Access Compliance Report

Public Rights-of-Way

Intersection ID: 16755	Main Street: DICKINSON_PL	Cross Street: PRINCETON_AV	Location: S
ADA ID: DC09B1C5AF85	Ramp Type: BlendTrans1	Initial Pass/Fail: Pass	Overall Compliance: No
Severity Score: 5.25			
Codes/Mitigation Info/Possible Solution		Field Measurements/Component Compliance

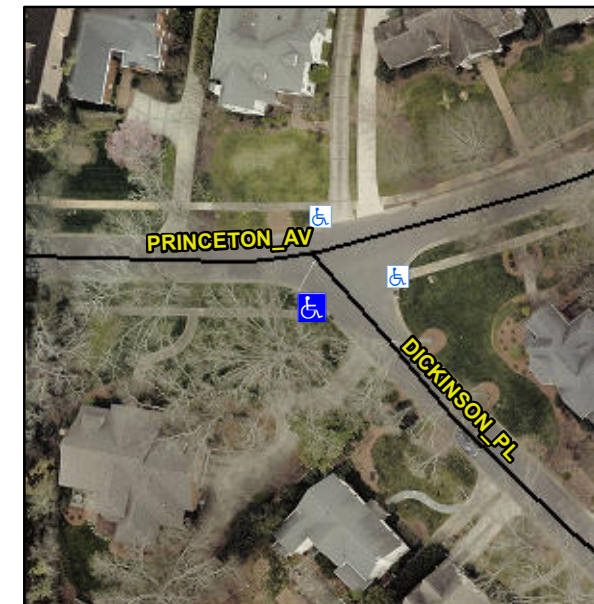
ASP LIP 0.5

Not Found, R304.5.3, R305.2, R304.5.4

Compliance	Description	Data	Compliance	Description	Data
N/A	Ramp Length (in)	67.0	Yes	BlendTrans Slope (%)	2.8
Yes	Ramp Width (in)	53.5	No	BlendTrans XSlope (%)	3.0
N/A	Flare Type LT	None	N/A	Flare Type RT	None
N/A	Flare Slope LT (%)	N/A	N/A	Flare Slope RT (%)	N/A
N/A	Flare Traversable LT?	N/A	N/A	Flare Traversable RT?	N/A
Yes	Landing Length (in)	61.0	Yes	DWS Provided?	Yes
Yes	Landing Width (in)	53.5	Yes	DWS Contrast?	Yes
Yes	Landing Slope (%)	0.7	Yes	DWS Length (in)	24.0
No	Landing X Slope (%)	3.5	Yes	DWS Full Width?	Yes
N/A	Landing Curb? (Y/N)	No	No	DWS Offset (in)	4.0
N/A	Shared Landing?	No			
Yes	Gutter Ponding?	No	No	Gutter Slope (%)	9.5
Yes	Gutter Lip Ht (in)	0.0	Yes	Gutter X Slope (%)	1.1
N/A	Painted X Walk1?	No	N/A	Painted X Walk2?	No
	X Walk 1 Direction	To NE		X Walk 2 Direction	To N
	X Walk 1 Width (in)	N/A		X Walk 2 Width (in)	N/A
	X Walk 1 Slope (%)	5.3		X Walk 2 Slope (%)	4.8
	X Walk 1 X Slope (%)	0.5		X Walk 2 X Slope (%)	0.9

N/A	Ramp inside XWalk1?	N/A	N/A	Ramp inside XWalk2?	N/A
	Road Slope (%)	0.4		Clear Space?	Yes
	Road X Slope (%)	6.5	N/A	Clear Space to XWalk (in)	N/A
Yes	Any Obstructions?	No	Yes	Storm Grate/Utility Hazard?	No
	Obstruction Type			Storm Grate/Utility Type	
		N/A			N/A
			Yes	Surface Condition? (G/P)	Good
			No	Curb Slope (%)	17.6

Remove & Replace Curb Ramp With Two New Directional Ramps or Equivalent. Remove & Replace Gutter.
